CITY OF ALBUQUERQUE

**Planning Department
Transportation Development Services Section**

Re: Certification Submittal for Final Building Certificate of Occupancy for
McCleod Crossing Bldgs 5-8, [F-17 / D2I]

Re: Mcleod Crossing Buildings 5 through 8, Traffic Circulation Layout
Engineer's Stamp dated 7-02-04 (F17-D2I)

FIGURE 1
OFFSITE DRAINAGE MAP
SCALE: 1"=300'

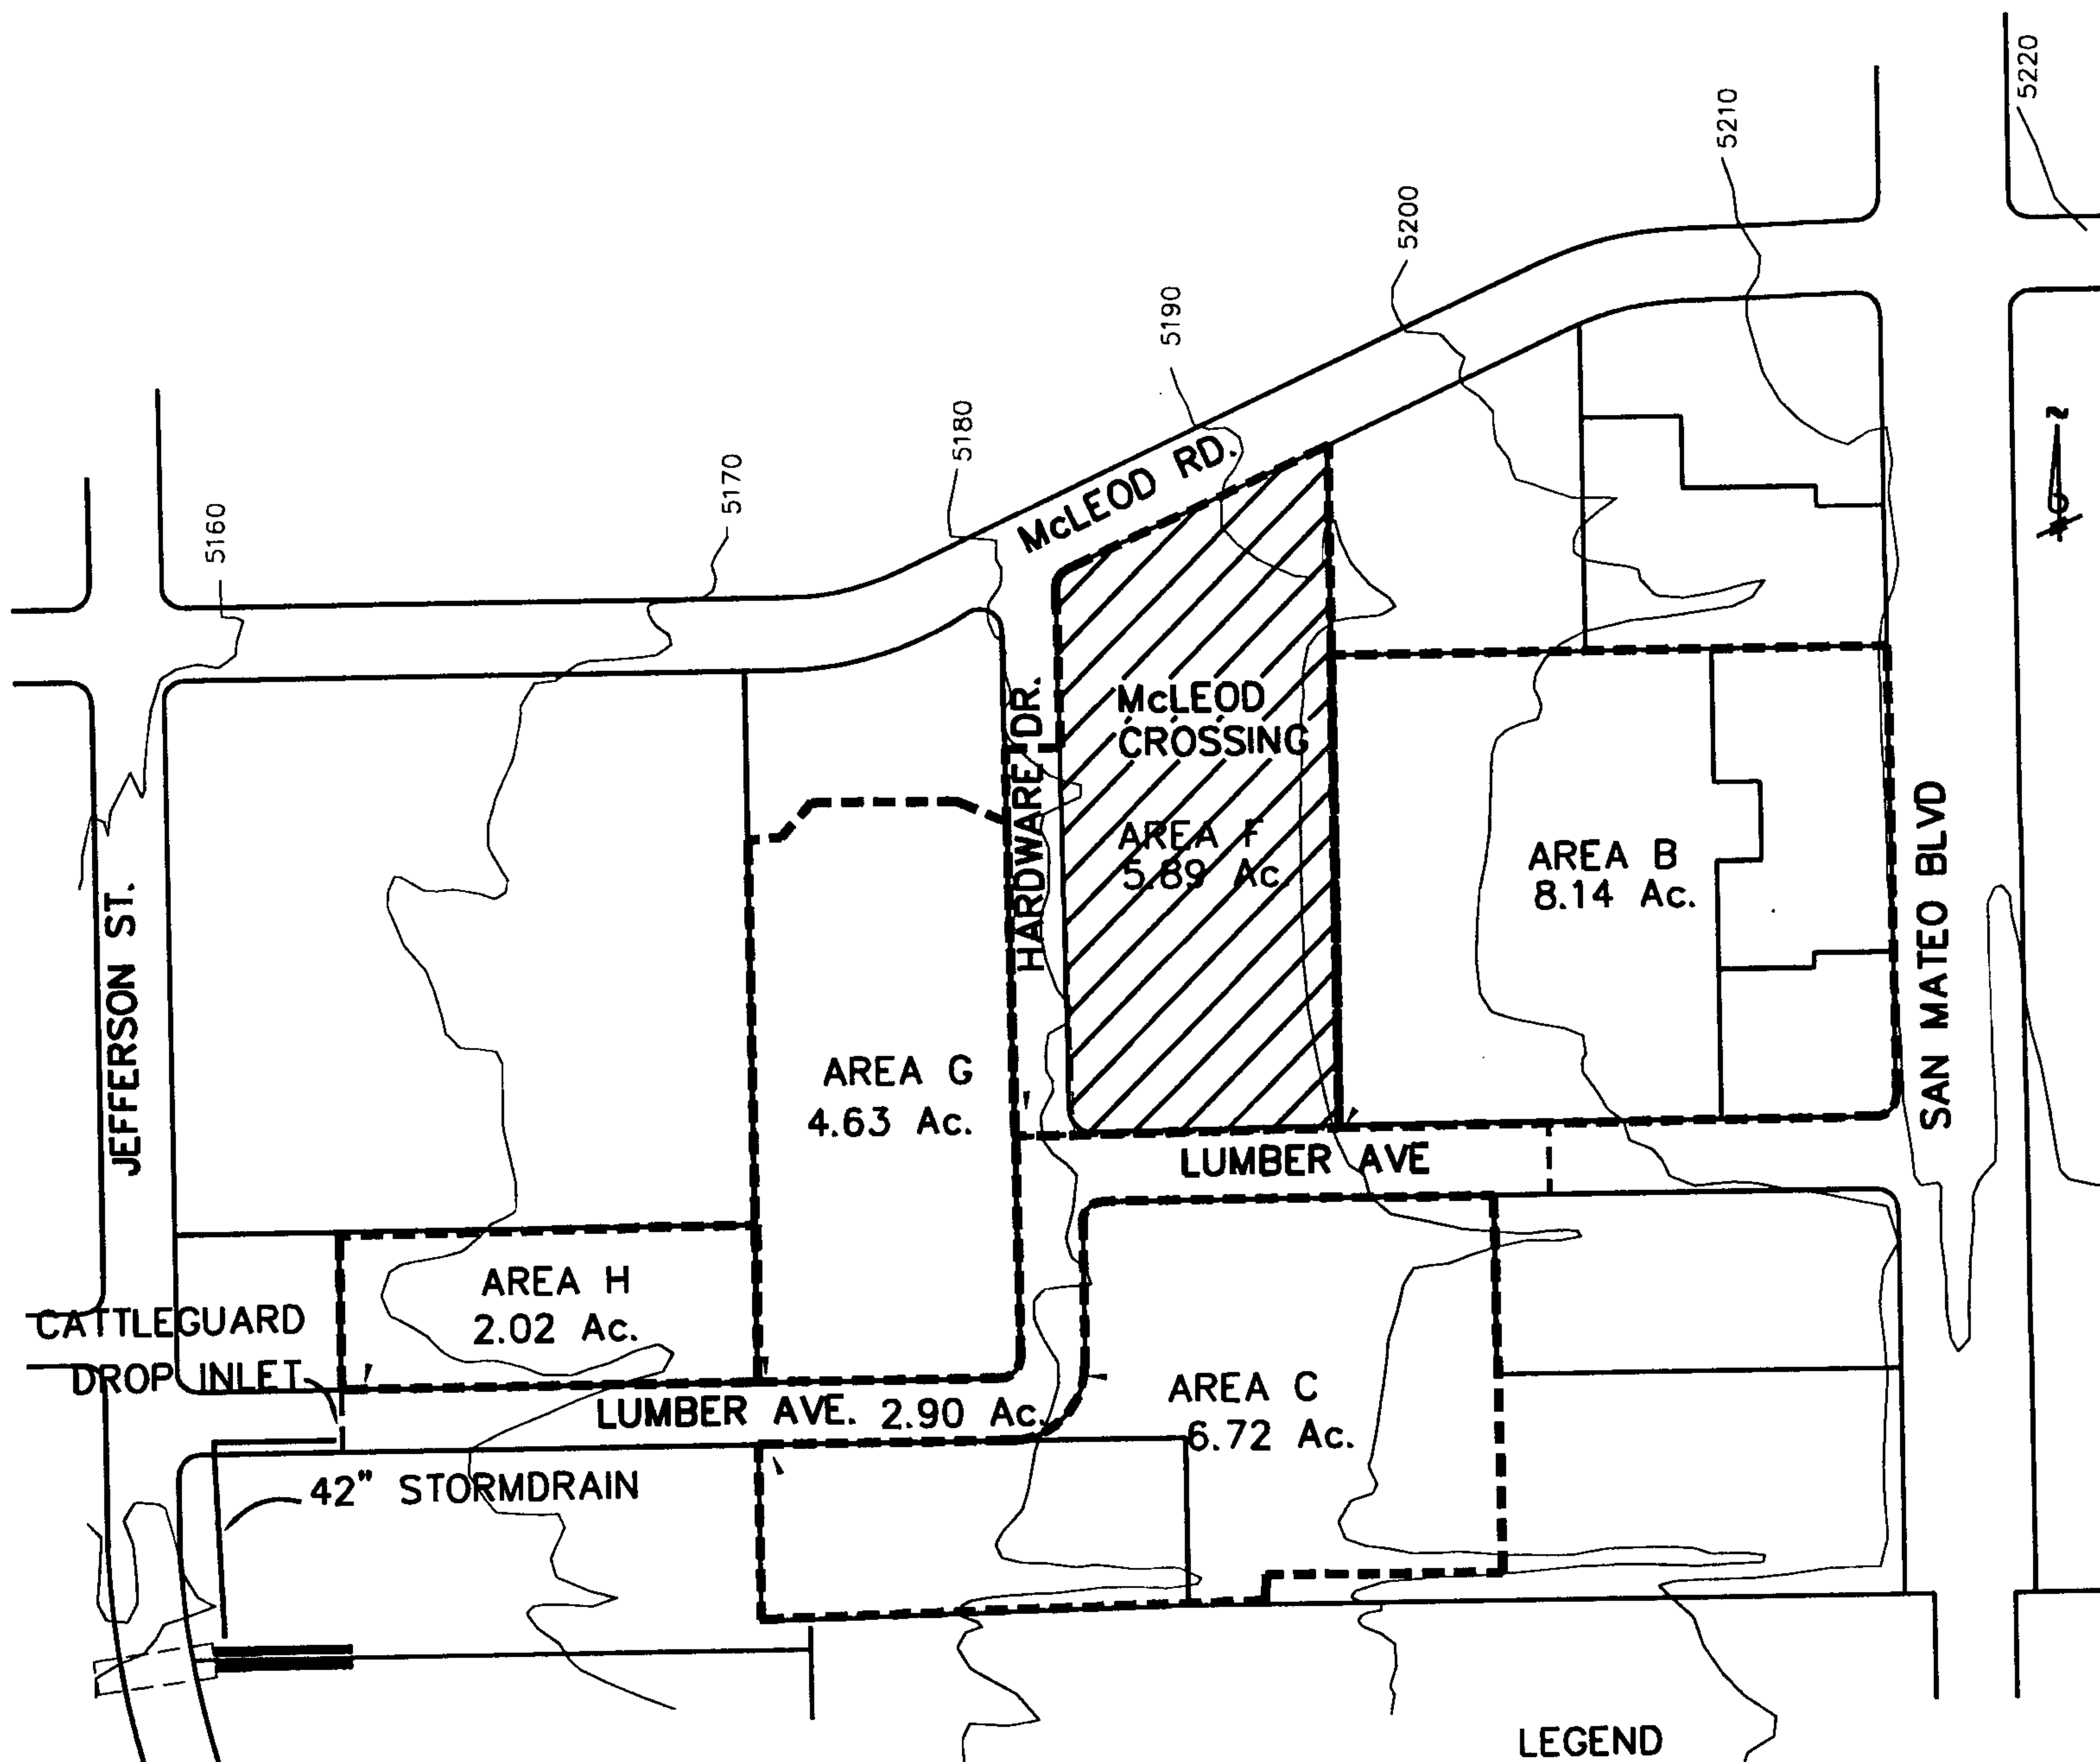
The contributing drainage area is shown on figure 1.

Figure 3 (included in an analysis done by Suzi Balogh P.E.) was taken from the Albuquerque Metropolitan Drainage Study (AMDS). It shows the capacity of the intersection of Lumber and Hardware and the capacity of the 90 degree turn on Lumber Ave. Area B and F contribute 58 cfs which is less than the 67 cfs capacity.
